UNITED STATES PATENT AND TRADEMARK OFFICE

10/619,003

Office Action Summary	Application No.	Applicant(s)	
	10/619,003	GOTO, TOSHINORI	
	Examiner	Art Unit	
	W. David Coleman	2823

DETAILED ACTION***Election/Restrictions***

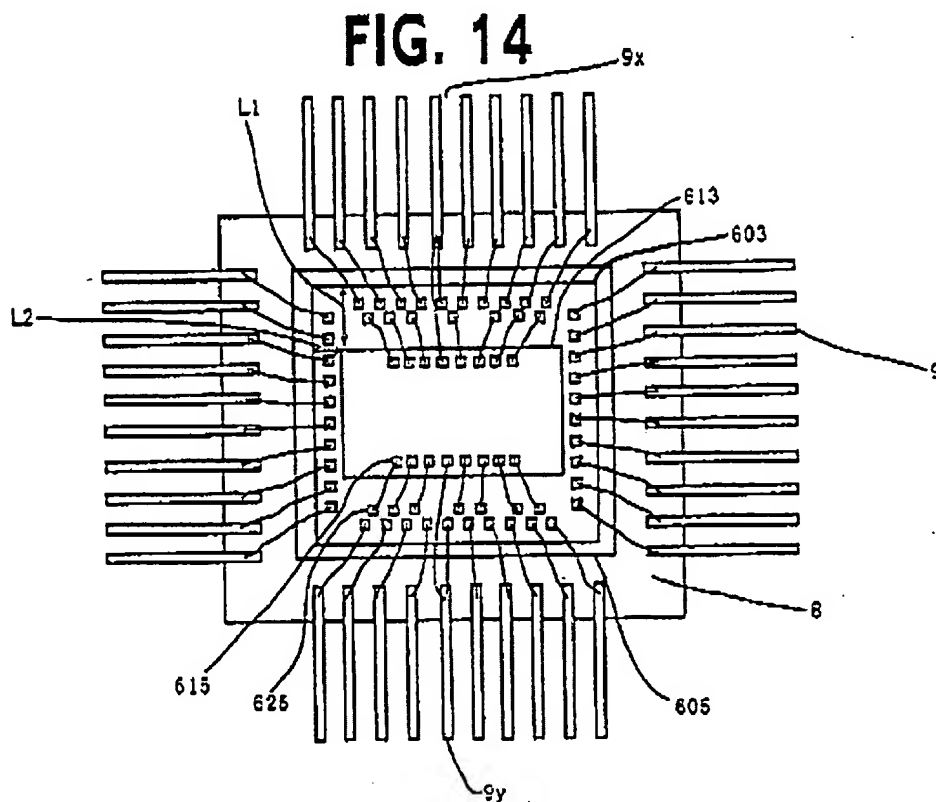
5. Pertaining to claim 18, Ohie teaches a method of manufacturing a semiconductor device having first and second semiconductor chips, comprising:

preparing the first and second semiconductor chips, the first semiconductor chip 103 having a first area which is free of the formation of elements which generate heat when in operation, and a second area which surrounds the first area; and

mounting the second semiconductor chip on the first semiconductor chip so as to arrange the second semiconductor chip 113 just above the first area of the first semiconductor chip.
